Comments on Draft 1
Traulsen
4/18/08

Below is the DRAFT 1 Version 2.0 product specification for ENERGY STAR qualified commercial refrigerators and freezers. A product must meet all of the identified criteria if it is to earn the ENERGY STAR.

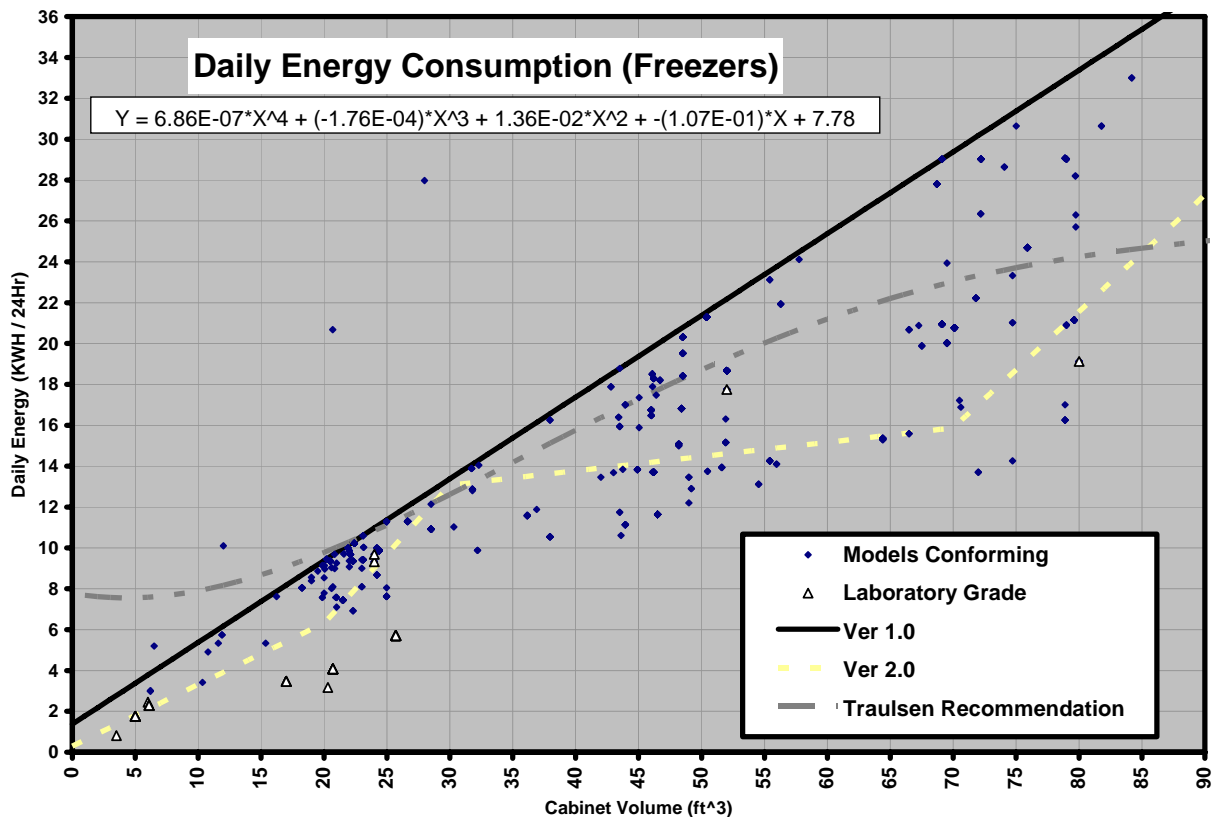
The proposed Traulsen curve corrects the error in the original E-Star “Version 1” standard for Freezers less than twenty cubic feet by raising the energy efficiency limit to realistically attainable value. It also shows an energy efficiency increase of 25% or more for cabinets with interior volumes greater than seventy-six cubic feet. The curve itself is a fourth order polynomial which accurately represents a realistic energy efficiency level based on today’s technology. (Please note: the current 2/1/2008” Energy Star database contains many questionable data points as outlined throughout this report commentary.)

The “Traulsen Recommendation” showing an increase in the allowable energy consumption for freezers under twenty cubic feet was based on the following analysis. (For expediency, the analysis focused on cabinets under ten cubic feet.)

1. *Of the nineteen models, under ten cubic feet, Listed in the Energy Star database, thirteen from a combination of [Biomedical Solutions, Inc.](#) and [Sci-Cool, Inc.](#) have no [ANSI/NSF Standard 7](#) Listing. (Neither company has any cabinets Listed to Standard 7. ([See above.](#))*

2. *One manufacturer, Nor-Lake has several models Listed with NSF for commercial food service applications, and another set of models marketed as “Scientific” or “Laboratory Grade” products. The [Nor-Lake, LF041](#) (([NSF File-1](#)), ([NSF File-2](#)) and ([NSF File-3](#))) at 3.5 cubic feet, is a freezer intended for the scientific market, and has no Standard 7 Listing.*

3. *The 6.5 cubic foot freezer from [Turbo Air, Inc., TUF-28](#) has a current Energy Star Listing of 5.2 KW-hrs / day. This rating is above the allowable energy efficiency limit set in “Version 1” of the E-Star specification.*

4. *In Traulsen’s review of Energy Star Listed freezers, the six cubic foot [Silver King, SKUCF7F](#) was obtained for laboratory testing. The interest revolved around the amazingly low energy consumption rate of 2.45 KW-hrs / day reported in the Energy Star database. After careful laboratory testing ([ASHRAE 72-2005, Turbo Air Inc, TUF-28.pdf](#)) the resultant data would suggest that the actual twenty-four hour energy usage rate is approximately 5.79 KW-hrs / day. If true, this model would not qualify under the current “Version 1” E-Star specification. Again, a gross error of this type contributes to the corruption of the E-Star database and adds to error of the “Version 2” specification.*

5. Now, after a very careful study at best only one freezer model under ten cubic feet (Three Listed in E-Star database, but all are exact same base cabinet and rating.) from a single manufacturer is available in the market. The 6.2 cubic foot [Beverage Air, UCF-27](#) model rated at 3.0 KW-hrs / day seems to conform at all requirements covered in this report commentary, but Traulsen is actively in the process of acquiring one to confirm the amazing low claimed energy consumption rate. Based on the Turbo Air, Inc. and Silver King models from above, one would expect the energy consumption rate to be in the range of 5 to 6 KW-hrs / day.
